Access Compliance Report

Public Rights-of-Way

(Curb Ramps)

Intersection ID: N/A	Main Street: ASCENSION_WY	Cross Street: INNOVATION_DR	Location: NW
ADA ID: 63240A824EC3	Ramp Type: Perp	Initial Pass/Fail: Fail	Overall Compliance: No
Severity Score: 12.5			
Codes/Mitigation Info/Possible Solution		Field Measurements/Component Compliance

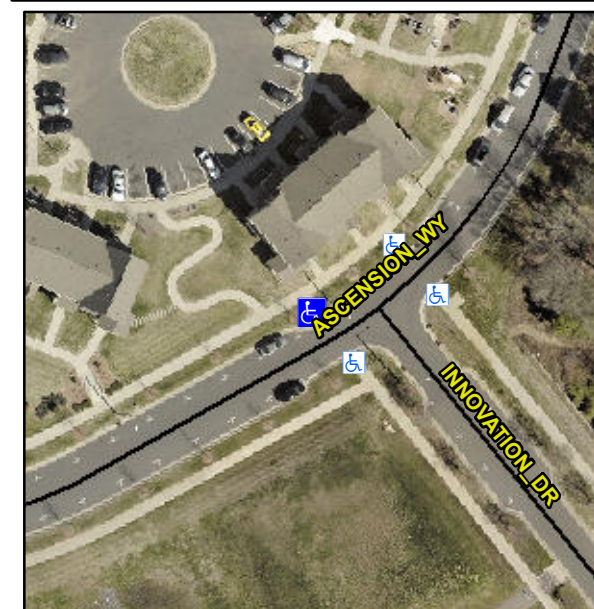
R304.2.2

Compliance	Description	Data	Compliance	Description	Data
N/A	Ramp Length (in)	73.0	No	Ramp Slope (%)	9.2
Yes	Ramp Width (in)	71.0	Yes	Ramp XSlope (%)	1.7
N/A	Flare Type LT	N/A	N/A	Flare Type RT	N/A
N/A	Flare Slope LT (%)	N/A	N/A	Flare Slope RT (%)	N/A
N/A	Flare Traversable LT?	N/A	N/A	Flare Traversable RT?	N/A
N/A	Landing Length (in)	N/A	N/A	DWS Provided?	N/A
N/A	Landing Width (in)	N/A	N/A	DWS Contrast?	N/A
N/A	Landing Slope (%)	N/A	N/A	DWS Length (in)	N/A
N/A	Landing X Slope (%)	N/A	N/A	DWS Full Width?	N/A
N/A	Landing Curb? (Y/N)	N/A	N/A	DWS Offset (in)	N/A
N/A	Shared Landing?	N/A			
N/A	Gutter Ponding?	N/A	N/A	Gutter Slope (%)	N/A
N/A	Gutter Lip Ht (in)	N/A	N/A	Gutter X Slope (%)	N/A
N/A	Painted X Walk1?	No	N/A	Painted X Walk2?	N/A
	X Walk 1 Direction	To SE		X Walk 2 Direction	N/A
N/A	X Walk 1 Width (in)	N/A	N/A	X Walk 2 Width (in)	N/A
	X Walk 1 Slope (%)	3.1		X Walk 2 Slope (%)	N/A
	X Walk 1 X Slope (%)	3.6		X Walk 2 X Slope (%)	N/A

Remove & Replace Entire Ramp.
